CITY OF ALLENTOWN

R90 - 2025

Certificate of Appropriateness for work in the Historic Districts:

WHEREAS, the following properties whose respective owners applied for and were granted approval by the Allentown Historic Architectural Review Board (HARB) to undertake specific exterior alterations on said properties as indicated in the attached Final Review Reports, which form part of this resolution:

Proposed Door Infill Area (City of Allentown)

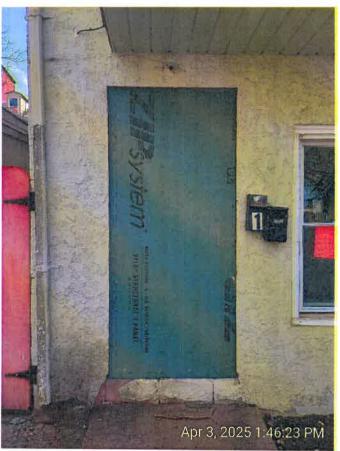
5/5/25 Observations & Comments: Infilling a doorway on a primary façade is not appropriate, as entry doors contribute to the composition of the primary façade. Removing a point of building egress may require approval by the Bureau of Building Standards and Safety, separate from HARB review. More information would be helpful to understand why door infill is the proposed solution; have other options been explored to maintain a secure entry?

- 1. If removal of the front door is acceptable to the HARB, the proposed exterior finish to match the adjacent stucco is appropriate.
- 2. Maintaining the existing first floor window that was previously covered over is appropriate. All visible windows appear to be vinyl replacement windows. While new vinyl windows are not appropriate per the Guidelines, 3.5.12 states "If replacing a single window on a façade, replicate the existing windows of that façade."
- 3. The proposed mailbox is a simple design and is appropriate.
- 4. Per the Guidelines, shutters should not be added where there is no evidence they existed historically. Vinyl shutters are not appropriate.

- Stucco over door infill is installed as presented.
- Mailboxes are installed as presented.
- Shutters are not installed.

- Stucco over door infill is installed as presented.
- Mailboxes are installed as presented.
- Shutters are not installed.
- Stoop Monroe Street is removed.

Streetscape (Applicant)

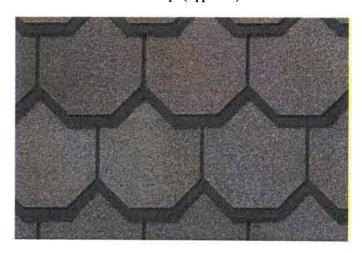
5/5/25 Observations & Comments: The slate steeple is a defining feature of the façade at 931 W. Gordon Street. Beveled and rectangular shingles create a dynamic pattern on the steeple.

While the proposed replacement product is of a similar beveled shape, replacement in-kind or with a synthetic slate would be appropriate. The size of the shingle also appears to be larger that the size of the slate shingle. More information would be helpful to understand if repairing the existing roof has been explored. If repair is not feasible, an appropriate alternative would be an alternative slate-look roof, such as GAF Slateline, or similar. Replacement materials should match the existing in color, pattern, shape, size, and profile.

The applicant brought a sample of the existing slate which fell off the steeple roof. He noted that he tried to reinstall slate shingles, which broke in the reinstallation process. While reviewing the existing steeple more closely, the slate towards the bottom of the steeple were observed to be in poor condition. The applicant brought samples for potential alternate materials, including the material proposed at the May 2025 HARB meeting, and GAF Slateline shingles. Mr. Jordan noted that the Slateline shingles were not consistent with the shaped slate- the current configuration of the slate installation is a combination of rows of rectangular/straight slates and rows of beveled/scalloped shingles.

If the current slate is beyond repair, the applicant proposes to use two styles of asphalt shingles to create a similar pattern as the current slate; however, the colors for the different shaped shingles are similar but not a complete match. Mr. Encelewski noted that maintaining the patterning of the shingles would be great and acknowledges that the slate appears to be in disrepair. Mr. Hart expressed concern about the loss of slate materials throughout the districts is a major issue but would defer to the board about the best alternate material. Ms. Shreier has concern about mixing two product types to replicate the pattern. Mr. Huber expressed that maintaining the pattern would be important to maintaining the character of the steeple and that it should be reflected in any replacement. Mr. Hammond preferred the shaped asphalt alternate material. Mr. Jordan said that there is evidence that the roof is in worse shape than anticipated and noted that the patterning of the existing roof is important across the board. The applicant noted that mixing two product types is physically possible and is open to a variety of options as recommended by the board.

Mr. Jordan moved to approve the application presented on 6/2/2025 for steeple roof replacement at 931 Gordon Street with the following conditions agreed to by the applicant, following section of the Guidelines for Historic Districts: Chapter 3, Section 3.1 Roofs, and found circumstances unique to the property in the unique patterning of the existing steeple:

• The proposed GAF Slateline and the proposed Certainteed Carriage House shingles are used in a unique pattern to replicate the existing pattern of the slate roof using four courses of Certaineed Carriagie house shingles to one course of Slateline.

Proposed Dormer Addition (Applicant)

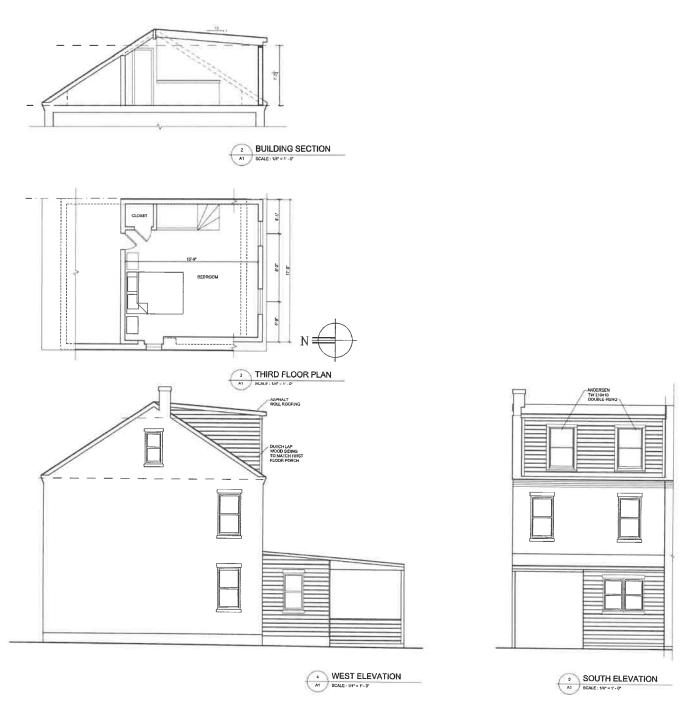
Staff reference Guideline 4.1.9, "dormer additions should not overwhelm the historic roof and should be scaled to preserve the predominance of the original roof form. New dormers are inappropriately large if they span from end to end of the original roof or if they reach from eave to ridge, or if they occupy the majority of the roof slope's area. New dormers on primary façade are rarely appropriate" and 4.1.26 "Design new dormers to be compatible with the existing architectural style and window pattern of the main building. Locate new dormers on rear or side roof slopes to reduce visibility."

- A dormer addition at the rear of the building is an appropriate location. There would be some visibility from Howard Street, and from Zieglers Court at the rear. It is not clear if the dormer would be completely obscured from view along Chew Street, or if it would be only minimally visible.

- The proposed dormer does occupy a majority of the rear roof. It would be helpful to understand if it is possible to reduce the overall width and/or length of the dormer.

- The proposal indicates two windows in the dormer. The 1/1 configuration is in keeping with the other windows on the building. More information would be helpful, including the materiality of the window, and overall dimensions. It appears that the windows are larger than the existing second floor windows, which does not follow the typical proportion of windows in dormers, which is that dormer windows are smaller than primary windows.

- The proposed siding is wood Dutch lap siding to match the rear first floor area. Wood lap siding is appropriate per the Guidelines. Per the Guidelines, all wood elements are to be painted.

- Gutters and downspouts were not included in the application materials. More information would be helpful to understand if these elements are intended to be included, and if so, the materials and profiles of those items.

- The dormer footprint is reduced in size in width and/or depth, so as to occupy less of the rear roof slope and be in a more similar proportion to other original dormers in the area.
- Window materiality is in keeping with the Guidelines.
- All wood elements are painted.
- Any proposed gutters and downspouts for the dormer are submitted for approval.

Mr. Hammond moved to approve the application presented on June 2, 2025, for the proposed dormer at 1022 Chew Street with the following conditions agreed to by the applicant, following sections of the Guidelines for Historic Districts: Chapters 3, Section 3.5 Windows and Chapter 4, Section 4.1 Additions to Buildings, and found circumstances unique to the property in the scaling of adjacent property rear dormers:

- o Window materiality is in keeping with the Guidelines; wood, aluminum clad wood, or fiberglass.
- o All wood elements are field or factory painted.
- Any proposed gutters and downspouts for the dormer are half round gutters and round downspouts, in keeping with the Guidelines, subject to staff approval.
